# City of Portland Design Commission

## Design Advice Request

### SUMMARY MEMO

**Date:** May 9, 2022  
**To:** Brian Varricchione, Mackenzie  
**From:** Benjamin Nielsen, BDS Design & Historic Review  
(503) 865-6519, benjamin.nielsen@portlandoregon.gov  
**Re:** EA 22-119814 DA – NE 7<sup>th</sup> Ave Apartments  
Design Advice Request Commission Summary Memo – April 21, 2022

MODIFICATION I PARKING SPACE DIMENSION

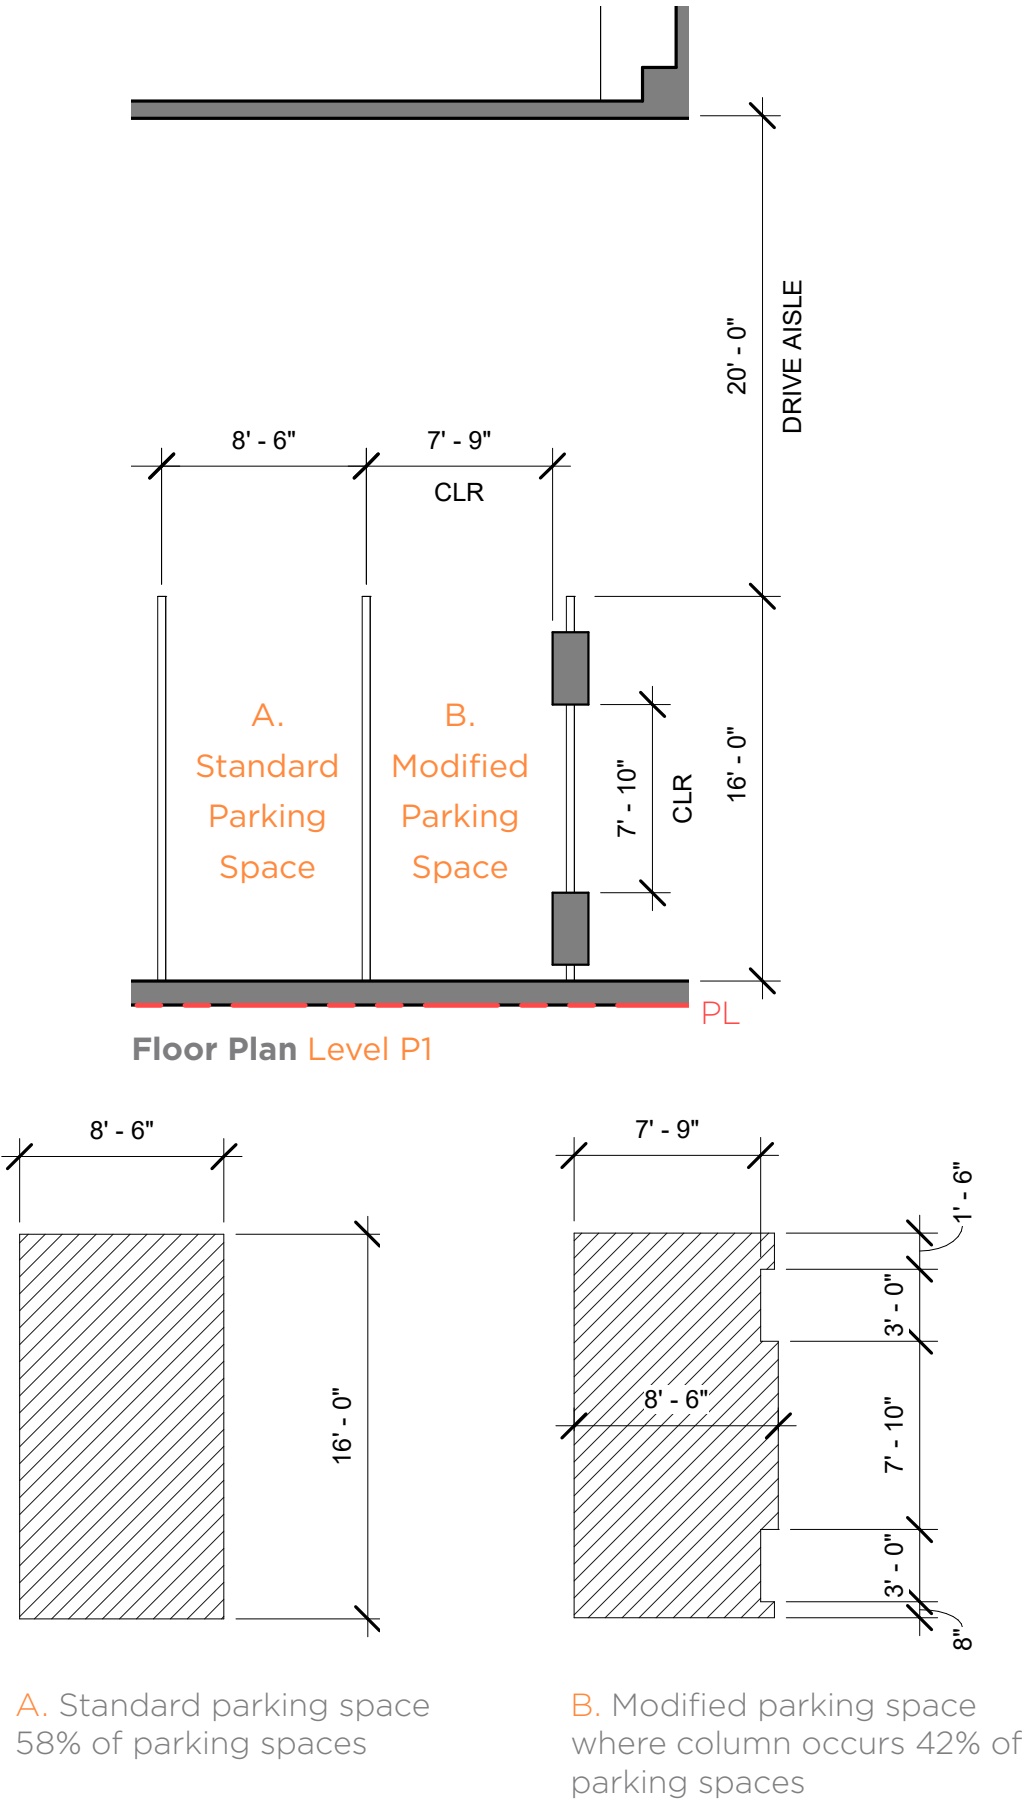
1. Commissioners said they believe the Modification to parking space width is supportable.

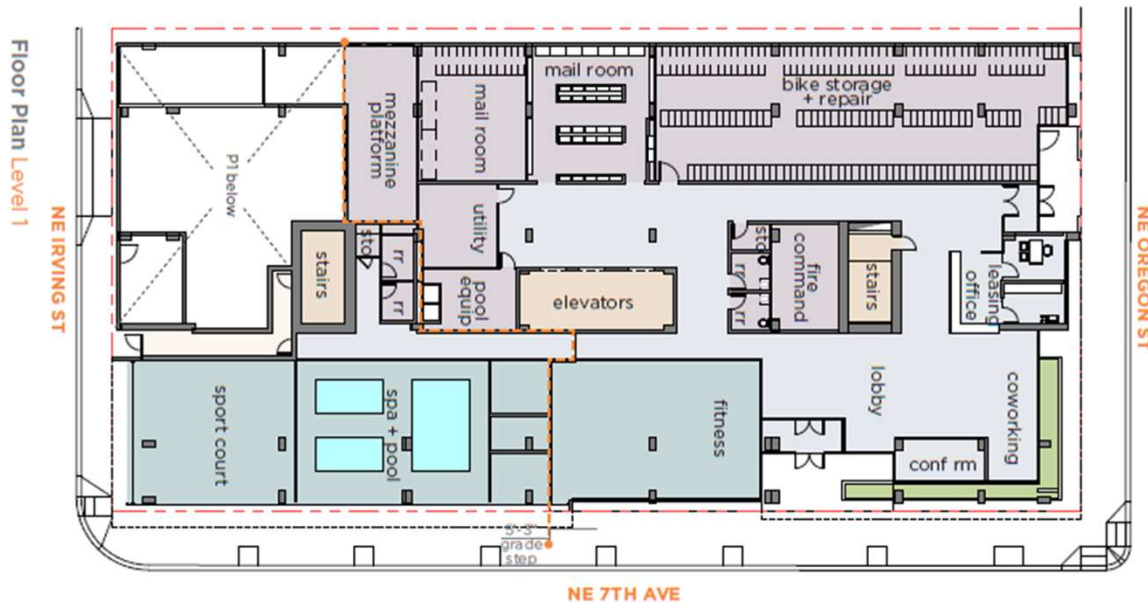
Texture is added to the building's facades with proposed mullion extensions. The building has a somewhat sculptural massing with a simple division along the north-south axis. Transparency of the windows is not yet clear.

The primary building material is lightly colored. Darker colors are reserved for the ground floor, recesses on the upper stories, and accents.

# Parking space size

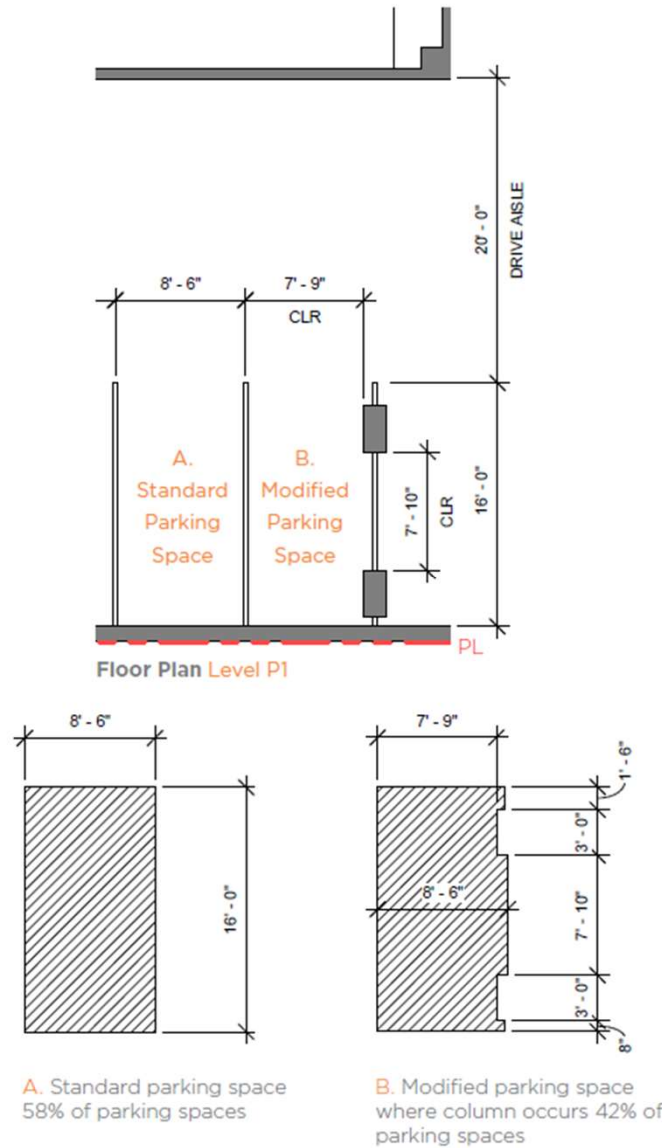
PZC 33.266.130.F.2 requires perpendicular parking spaces to be at least 8'-6" wide with a 20'-0" drive aisle.
